**Re: Chase Bank - Eubank**  
**340 Eubank Blvd NE, 87123**  
**30-Day Temporary Certificate of Occupancy**  
**Transportation Development Final Inspection**  
Engineer's/Architect's Stamp dated 9-2-20 (K21D009C)  
Certification dated 4-26-21

**TRAFFIC CIRCULATION PLAN**

PLT DATE  
09/02/20  
DRAWING SCALE  
1" = 10'  
PROJECT NUMBER  
CDC20014  
SHEET NUMBER  
C1.02

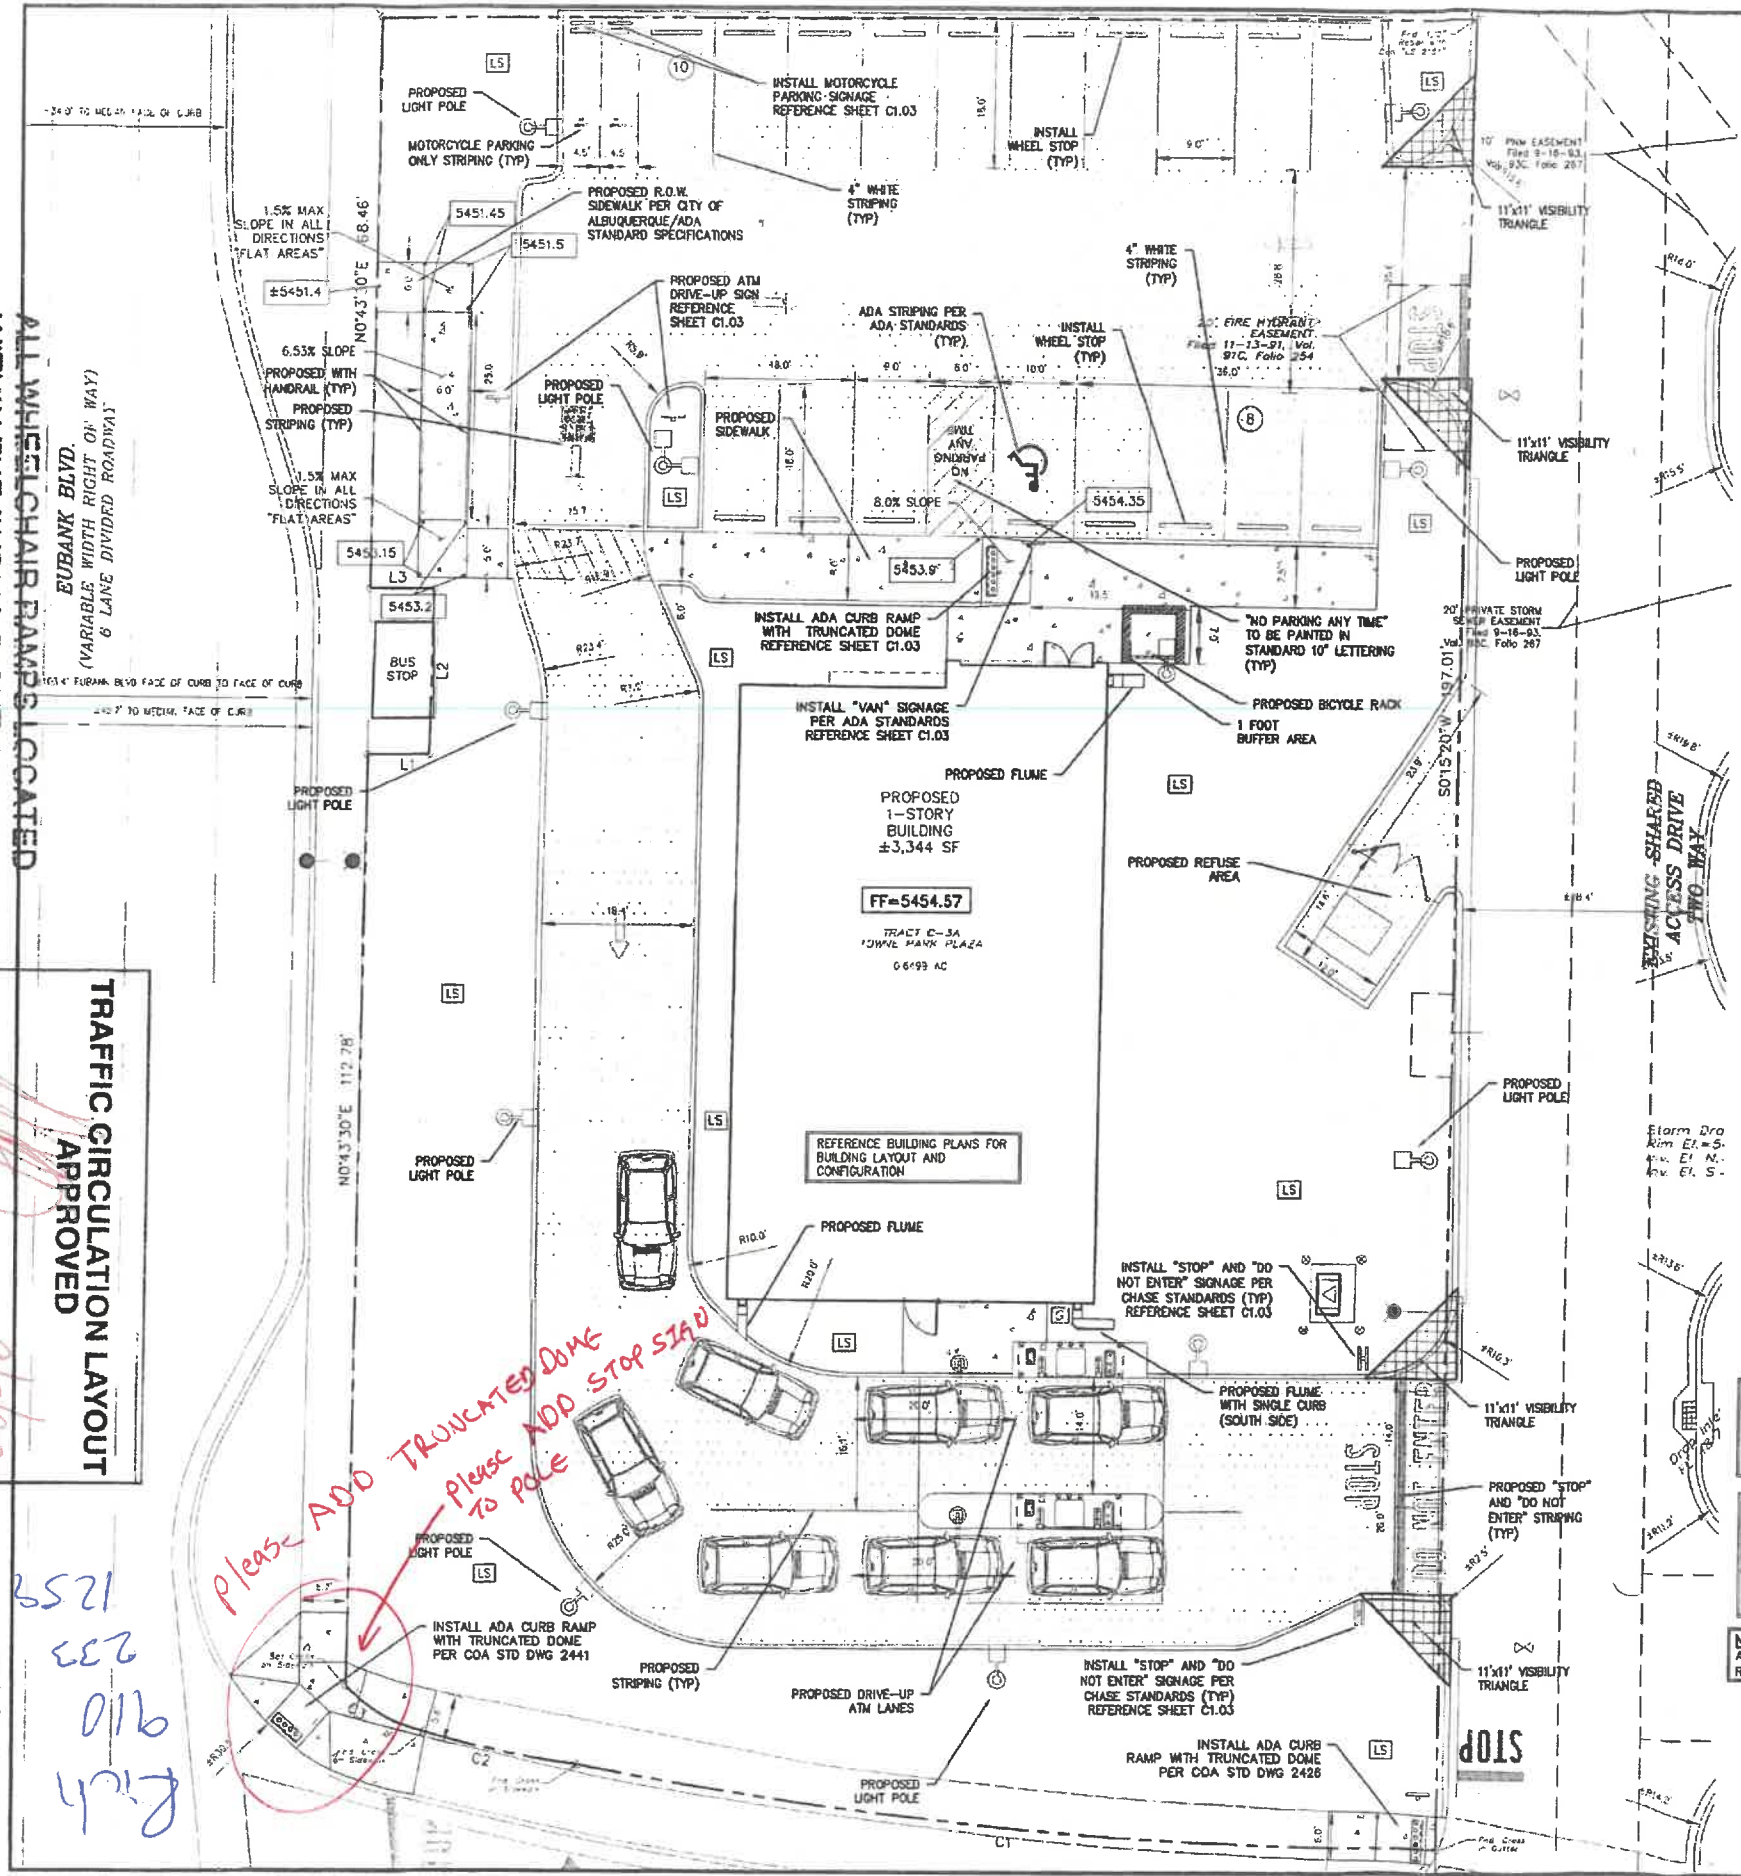
- Please add Truncated Dome and Stop Sign. See attached plan for location.
- Please remove construction debris and equipment from site.

Please ADD TRUNCATED DOME  
Please ADD STOP SIGN  
to pole

*Two missing stop signs need to still be installed.*
